SR 3/US 41/Northside Parkway/ Cobb Parkway

**Project Number: BHFST-0001-05 (024), P.I. No.: 720125
and CSSTP-0009-00 (410), P.I. No.: 0009410
Fulton/Cobb Counties**

Value Engineering Study Report

August 2009

DESCRIPTION: **IN PHASE I, USE SOIL NAIL WALL FOR WALL NO. 1 IN LIEU OF A MECHANICALLY STABILIZED EMBANKMENT WALL** SHEET NO.: **1 of 6**

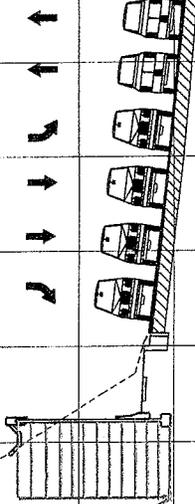
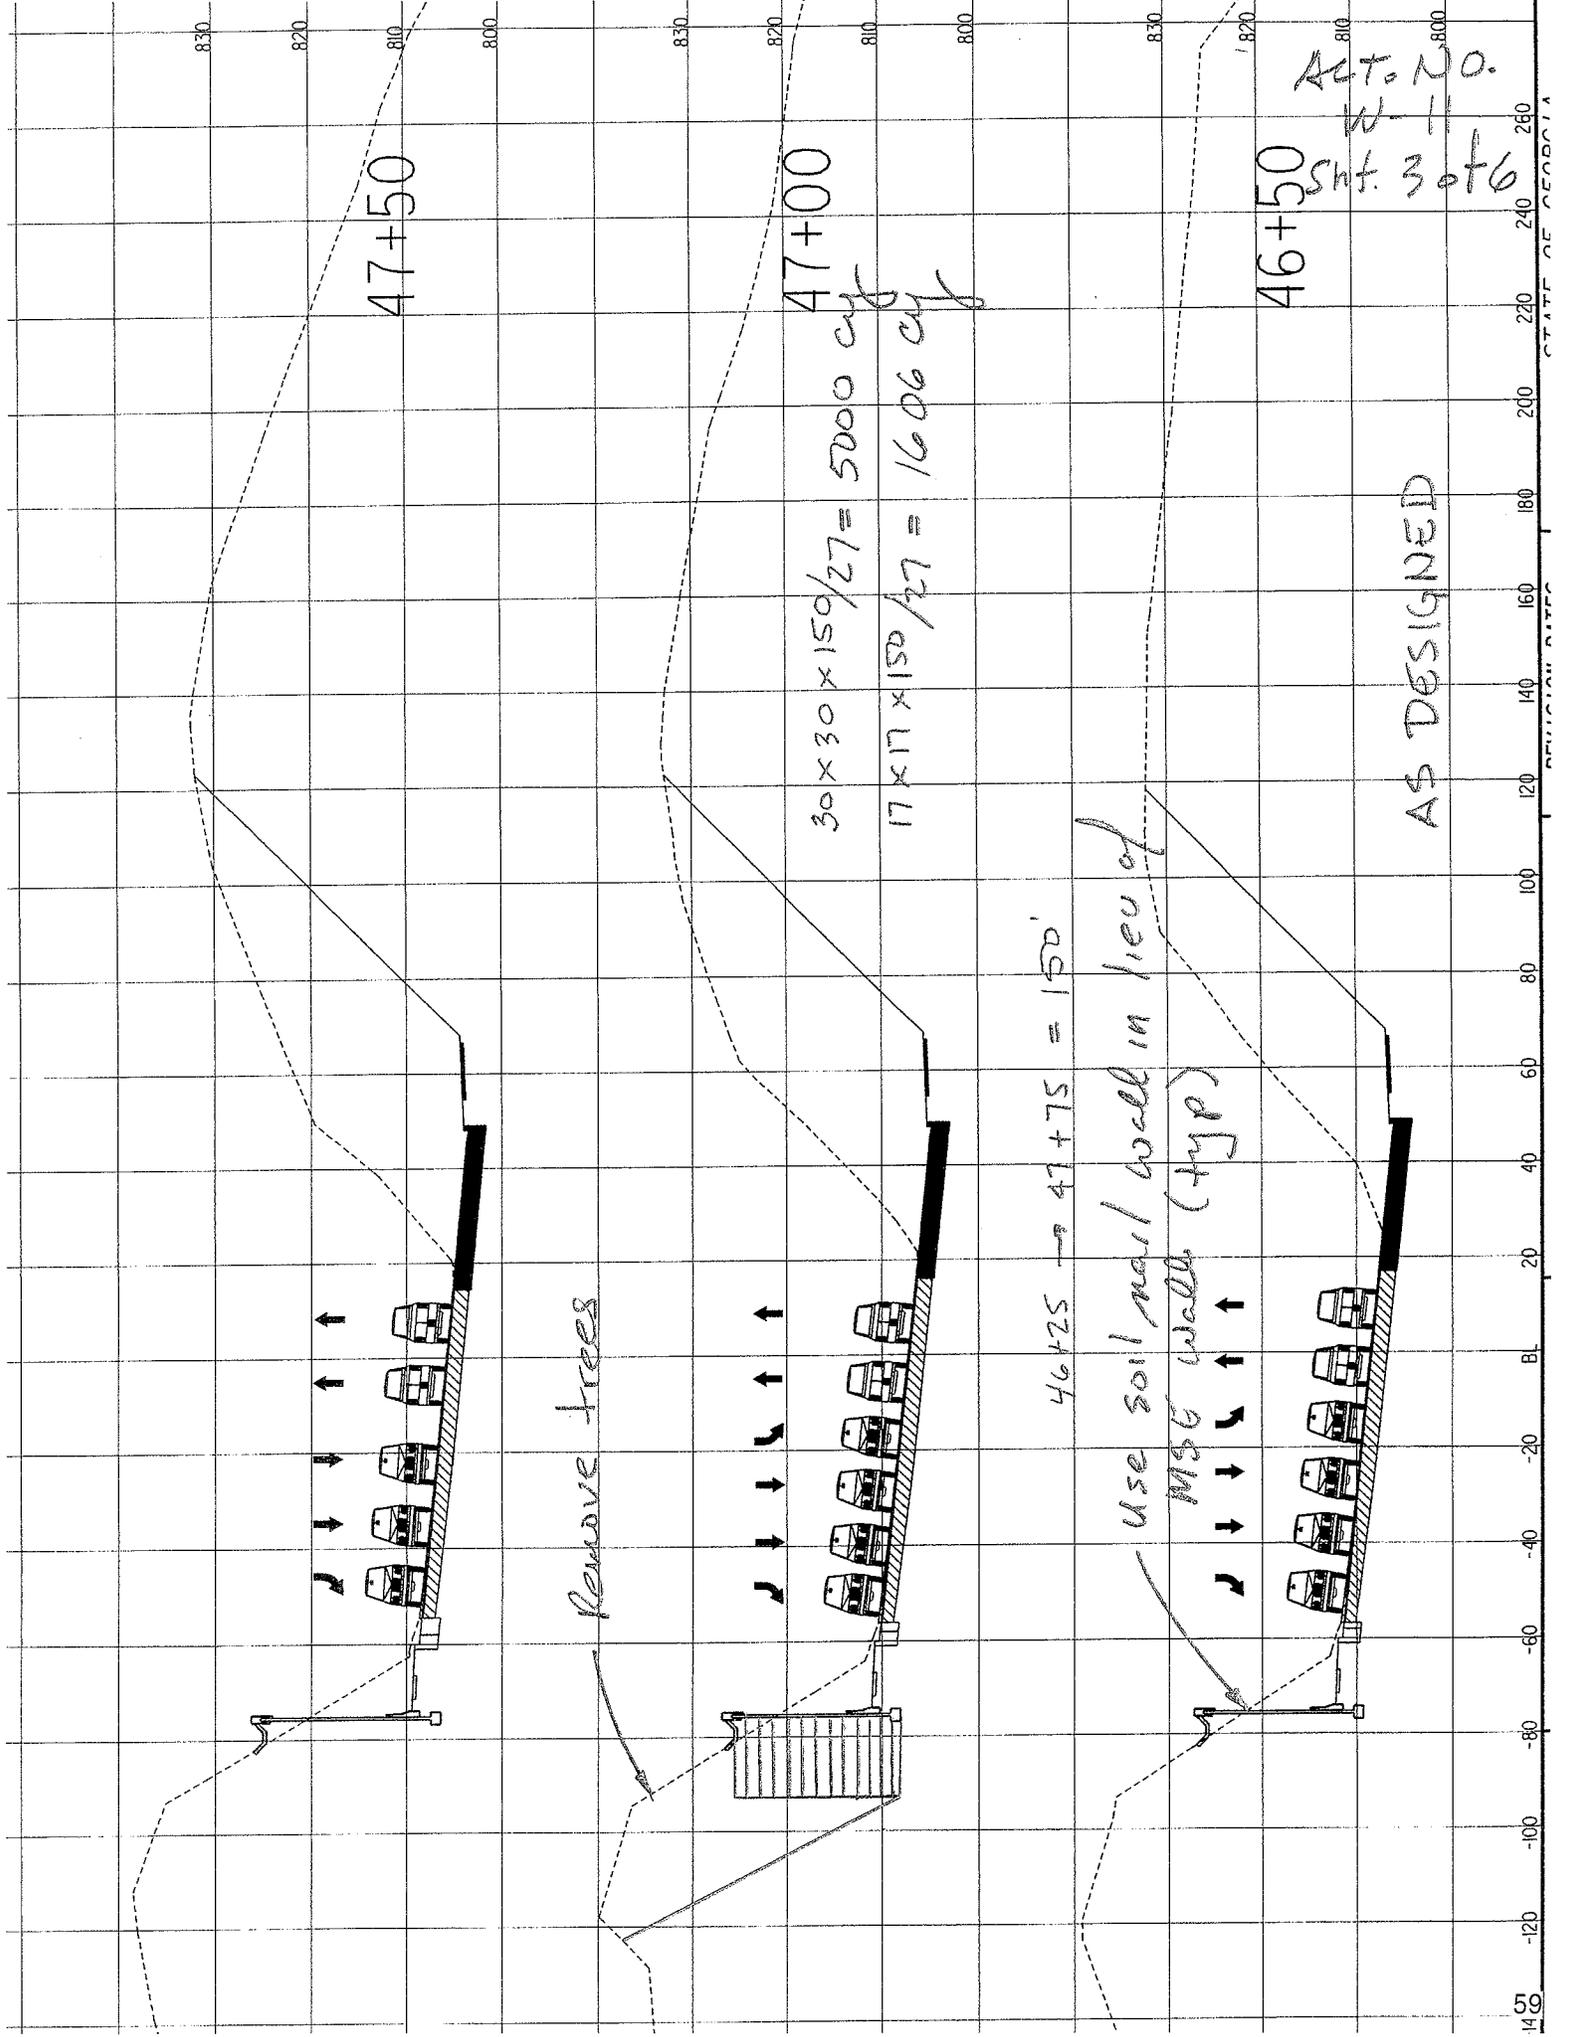
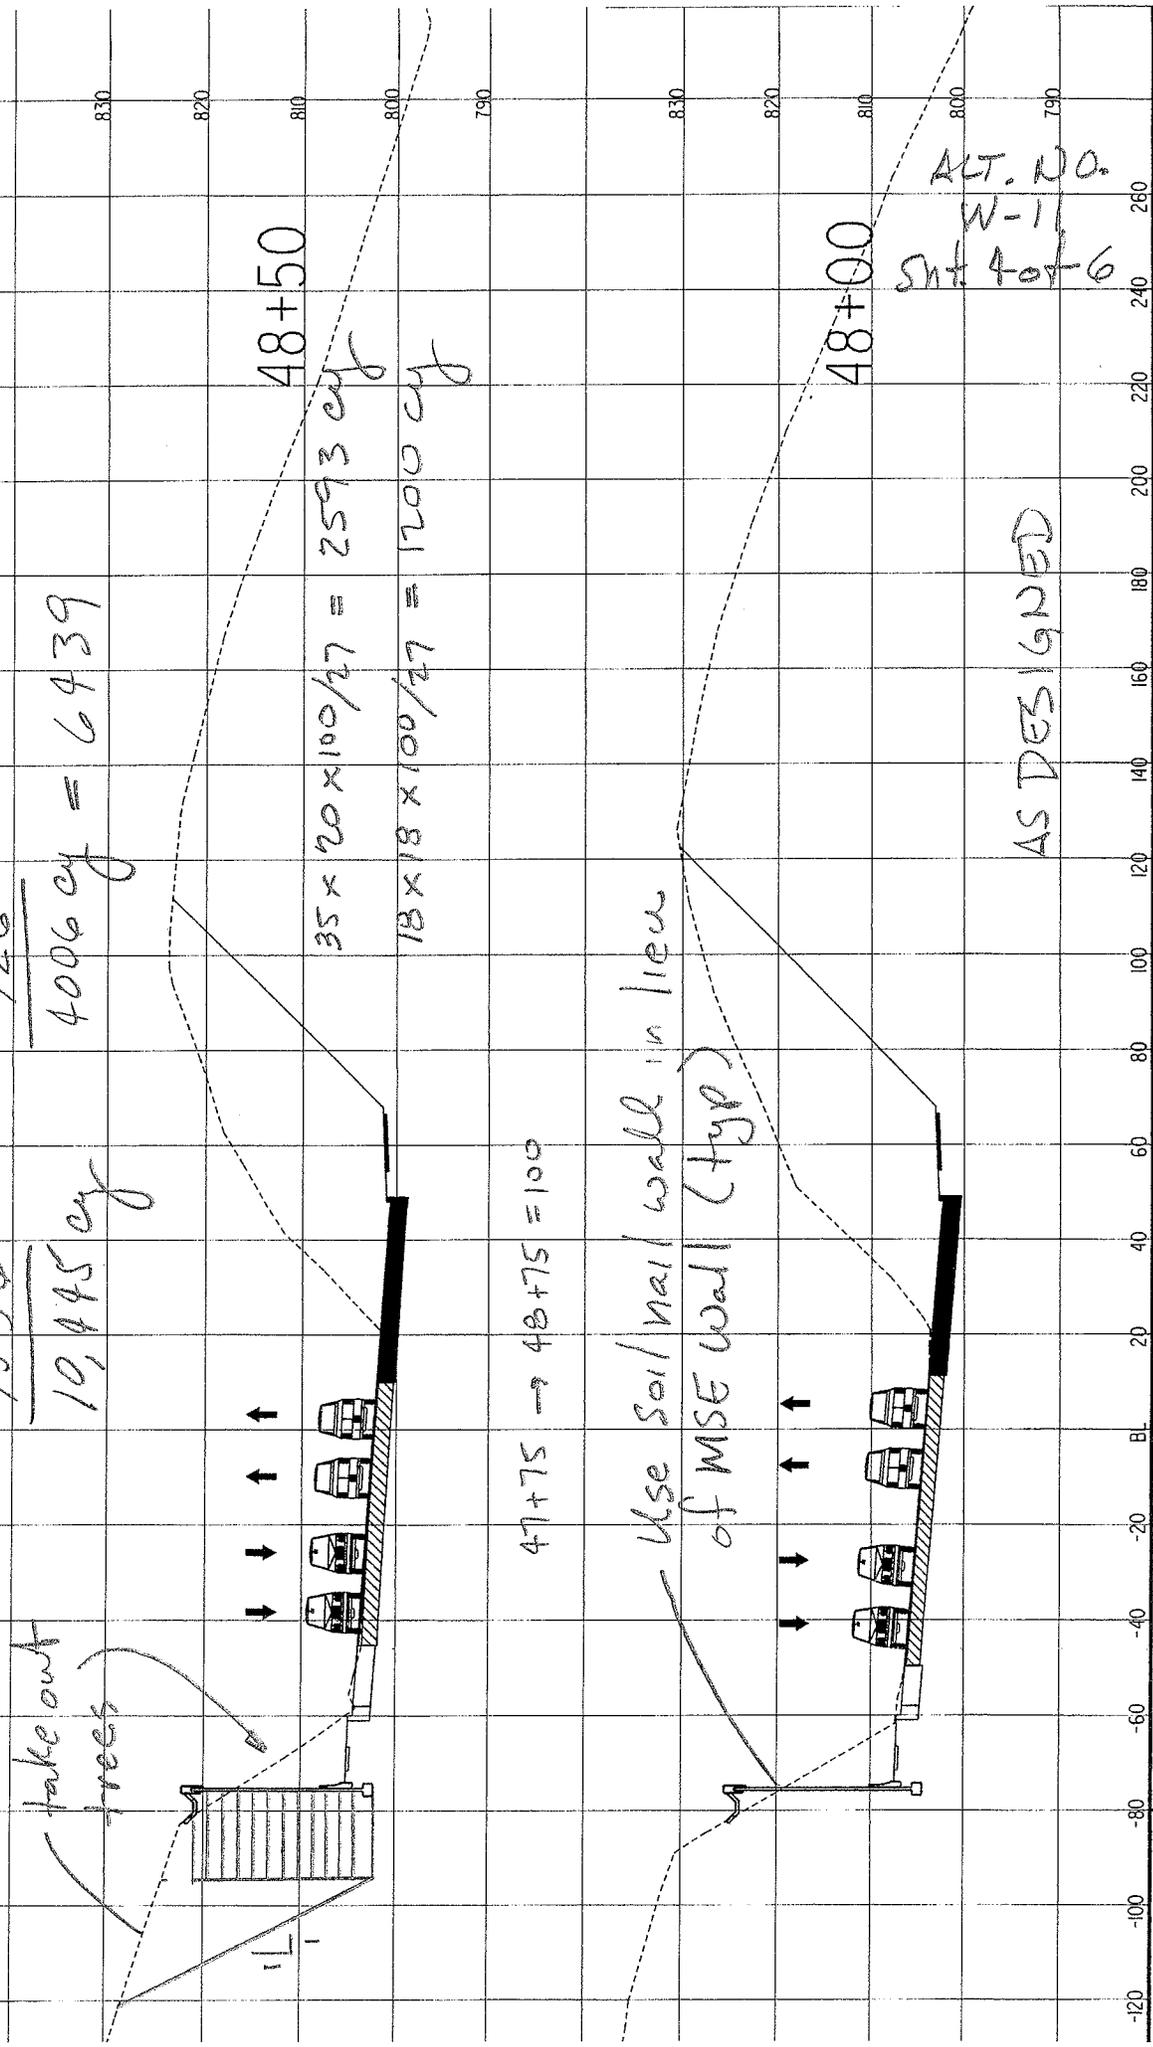
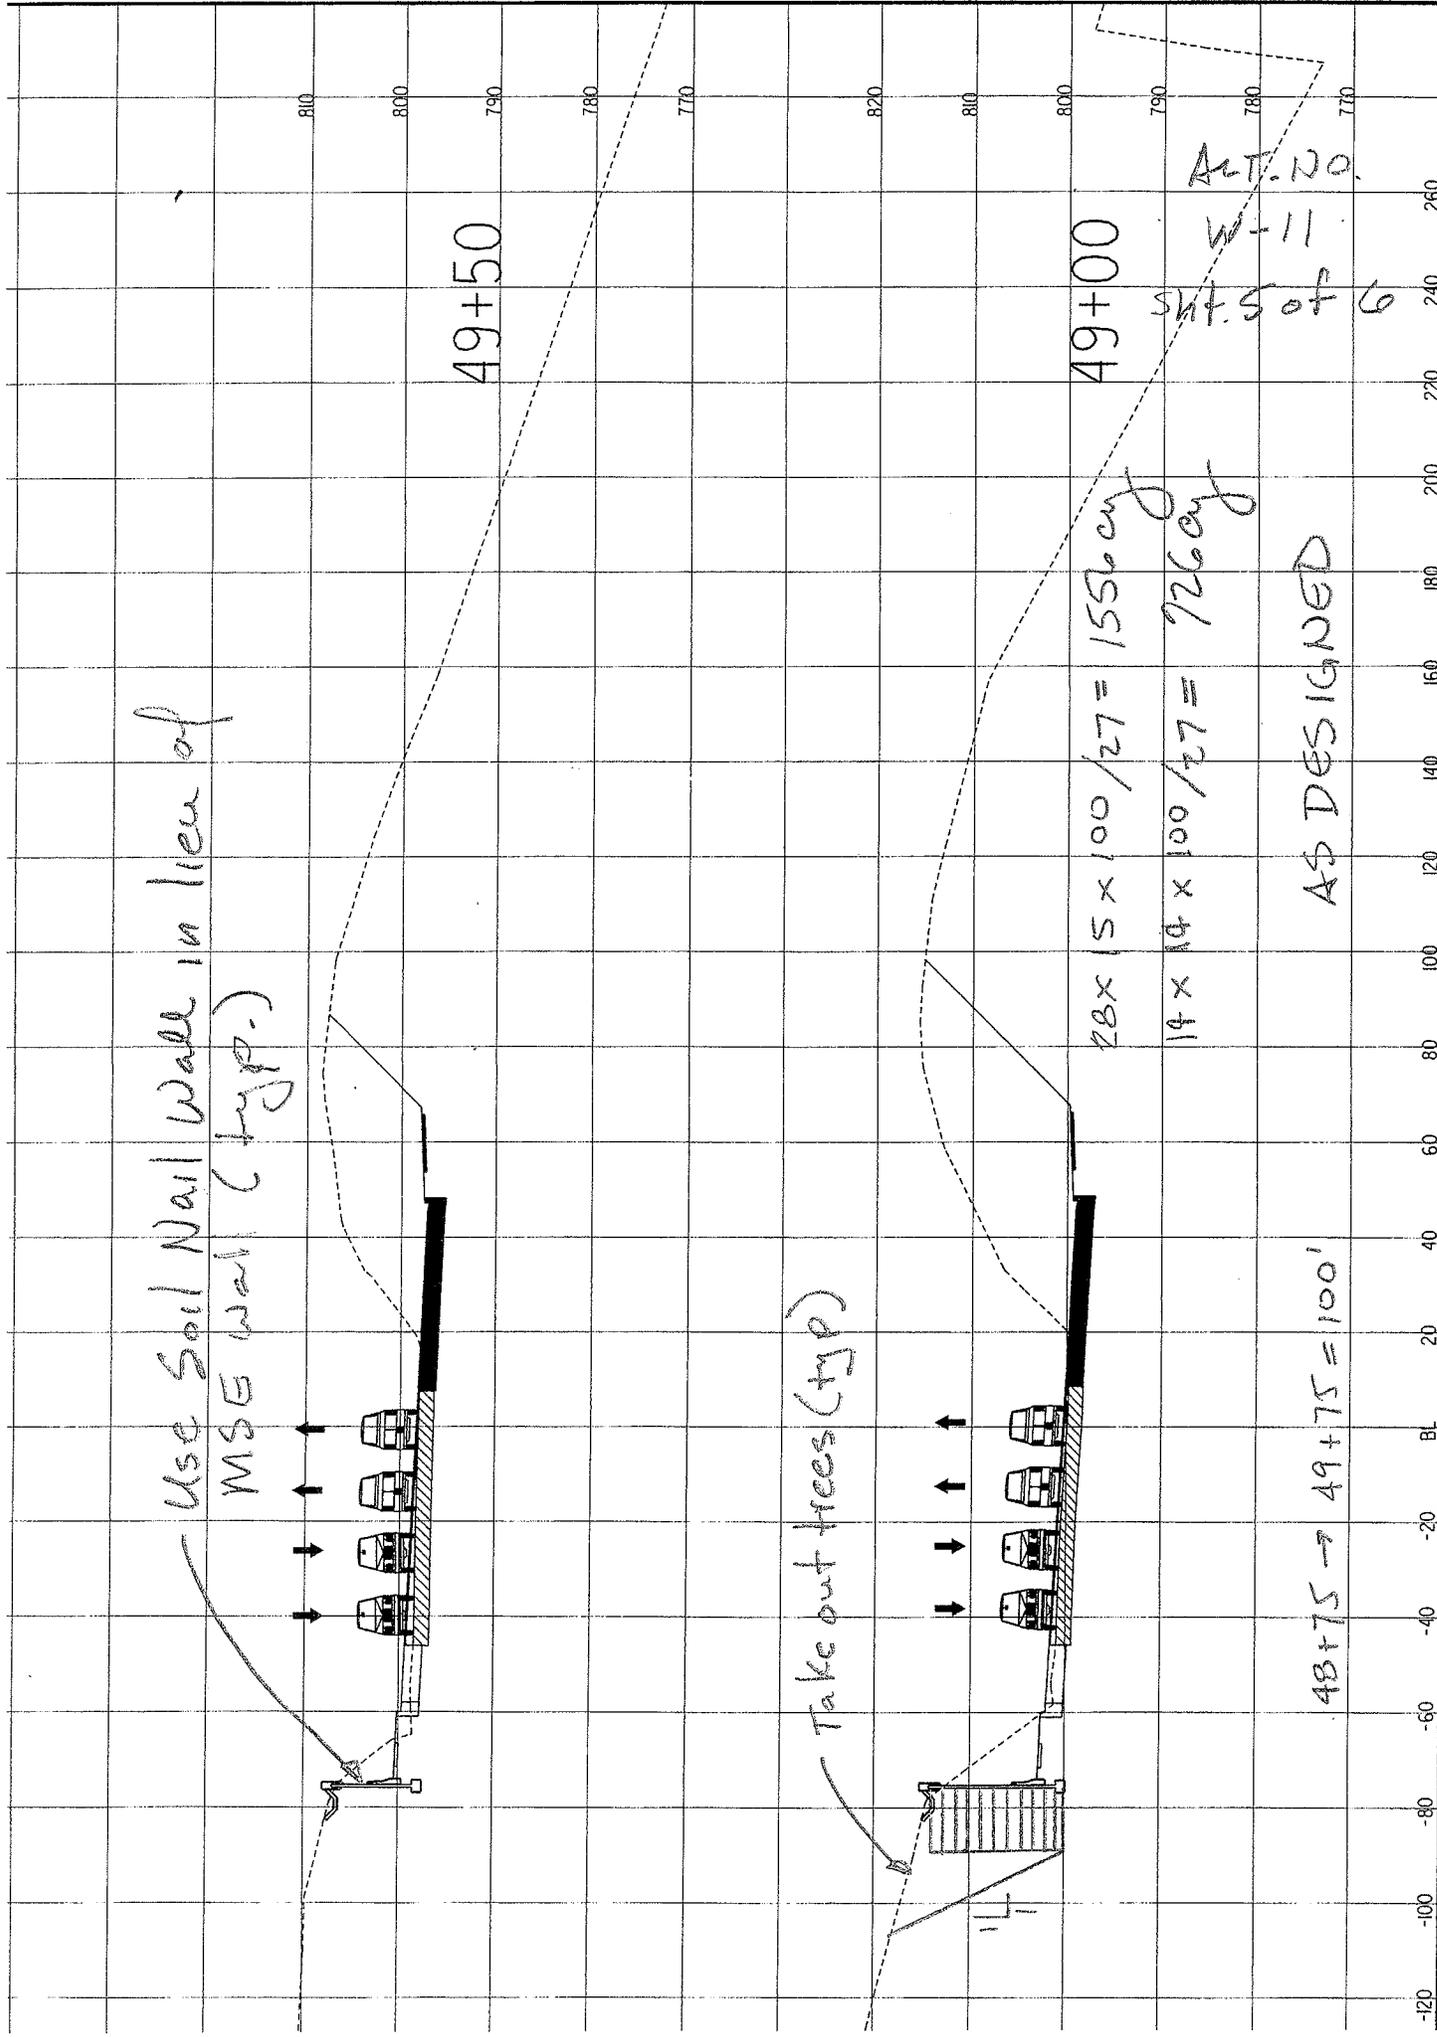
This alternative is being presented because in order to construct the MSE wall, a treed hillside separating SR 3/US 41 from a subdivision of single family homes will have to be removed and replaced with a grassed hillside. This will eliminate the natural buffer between the residences and the road allowing noise to migrate toward the residences. Construction of the soil nail wall will only require removal of some of the trees at the bottom of the hill, thus retaining most of the buffer.

take out trees

Remove trees

Use soil/nail wall in lieu of MSE wall (typ)

SUBJECT: Sketch
Alt. R-1
Phase 1 & 2

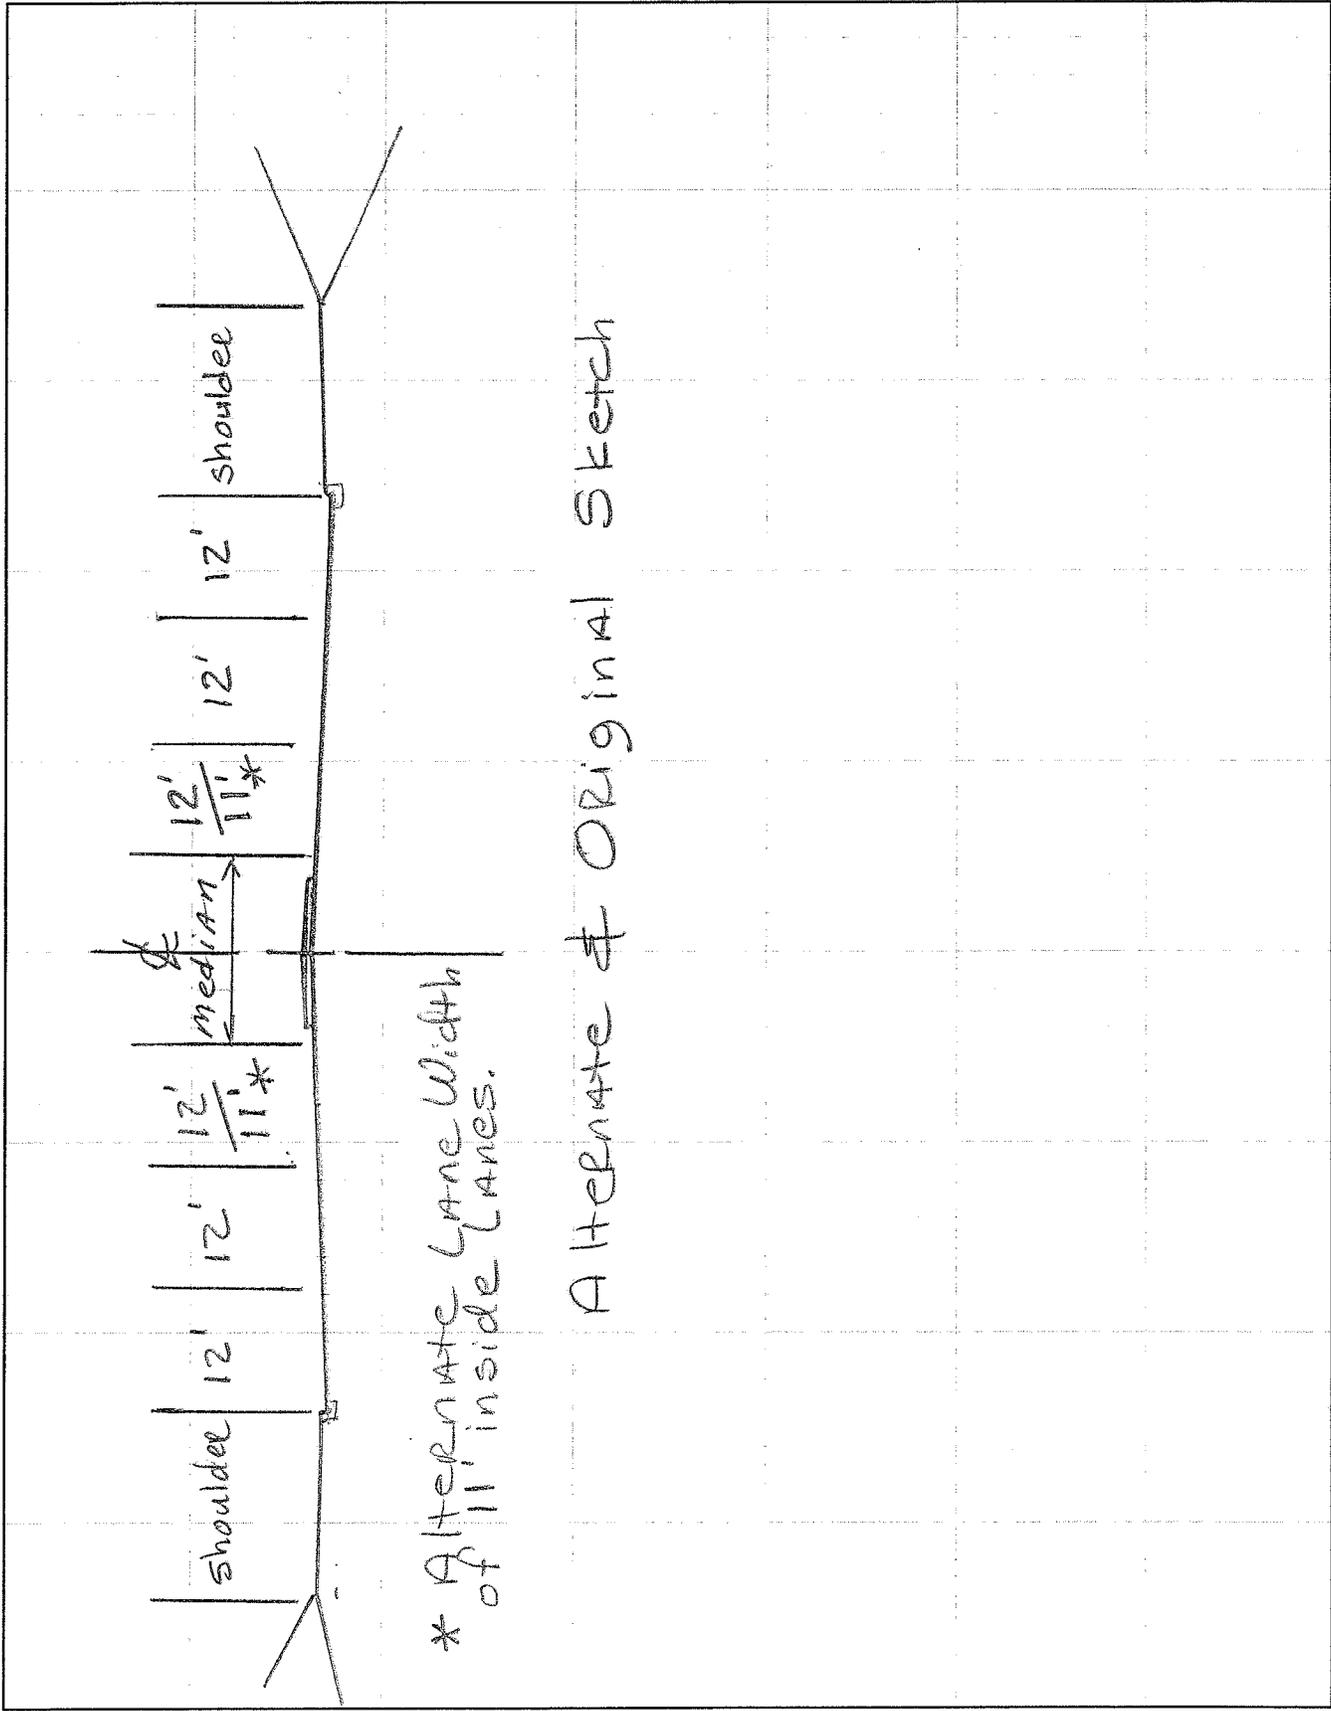
DESCRIPTION: **USE 11-FT-WIDE INSIDE LANES IN LIEU OF 12-FT-WIDE LANES IN EACH DIRECTION** SHEET NO.: **1 of 5**
